ADDENDUM NO. 1

**JACKSON ELEMENTARY SCHOOL RENOVATIONS
Valparaiso, IN 46304**

This Addendum consists of page ADD 1-1 and attached Addendum No. 1 from Gibraltar Design dated November 9, 2022 and consisting of 4 pages and 29 drawings.

Addendum One (AD.01) to the drawings and specifications prepared by Gibraltar Design for **Jackson Elementary School Renovations** for Duneland School Corporation, Chesterton, Indiana.

Wednesday, 11/9/2022 - 9:15 AM - LAST SAVED BY: CONELSON
Y:\21-143 DUNELAND SC - JACKSON ES ADDITIONS AND
RENOVATIONS\21-143 DRAWINGS\05 ARCH\A-702.DWG

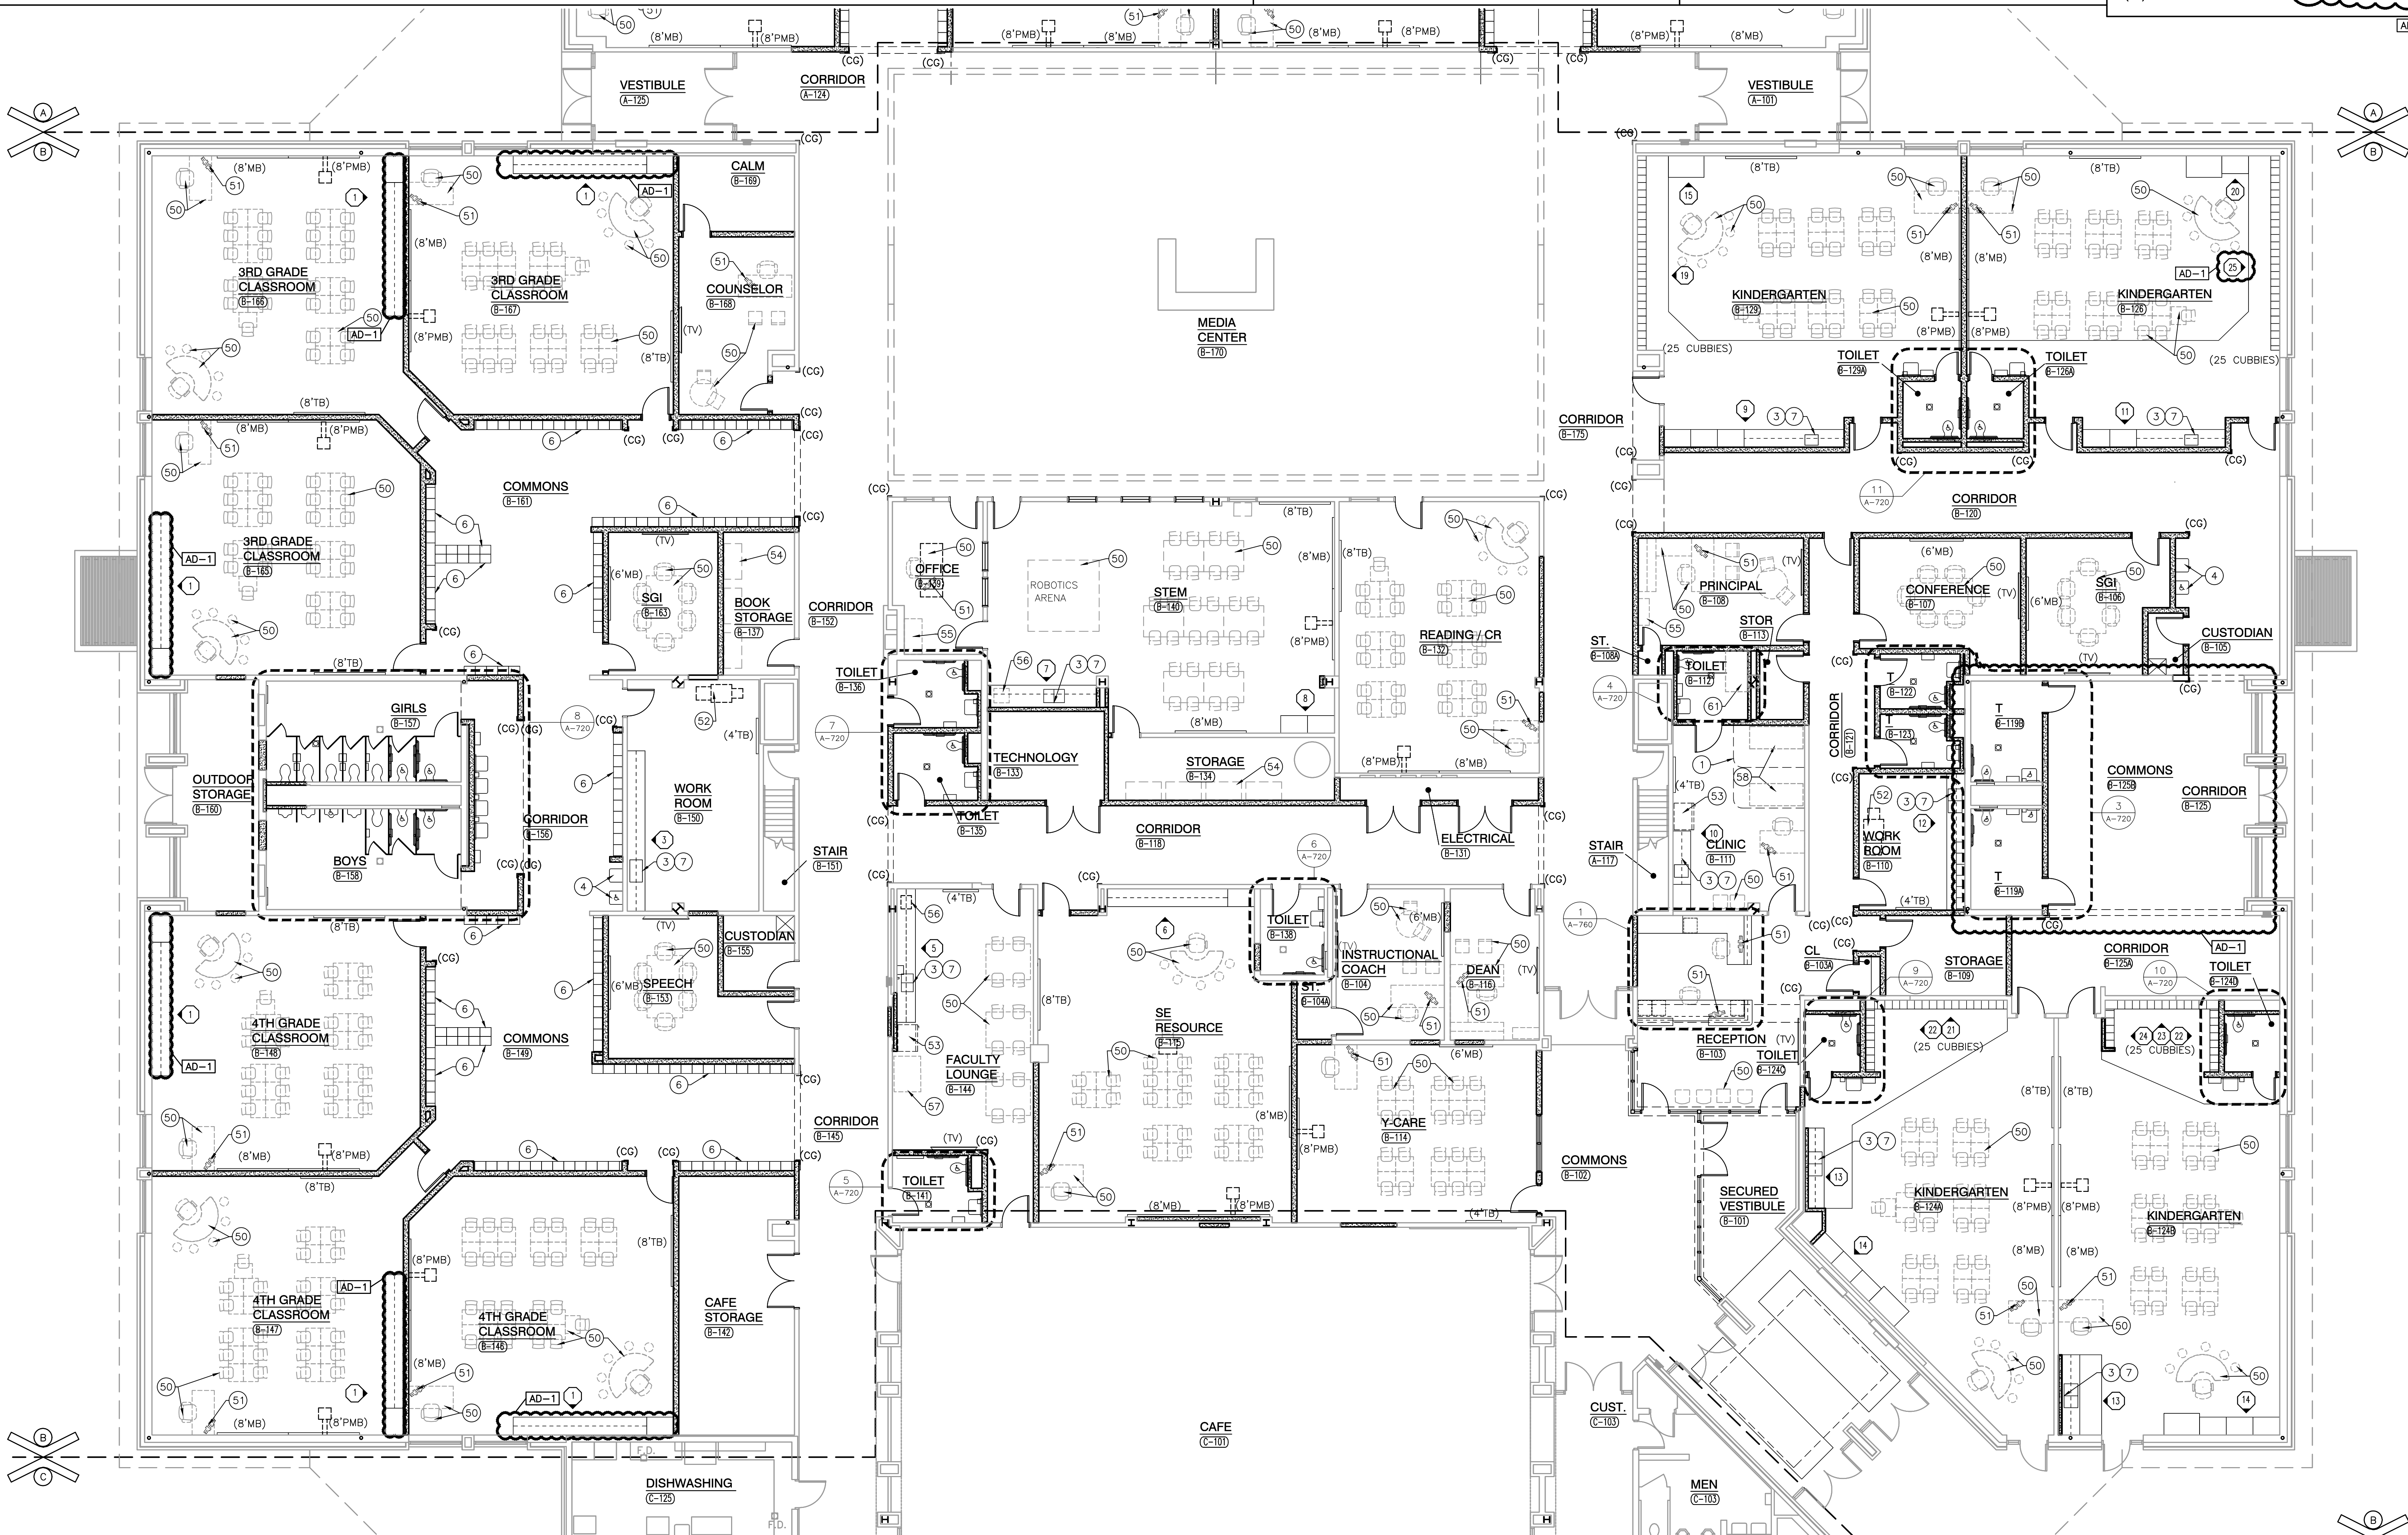
6. Sheet A-702

- A. Refer to revised full size drawing, included in this Addendum, for the following revisions:
 - 1. Plan casework length change in classrooms.
 - 2. Plan modifications, Commons B-125B.
 - 3. Note added detail number for roller shades.
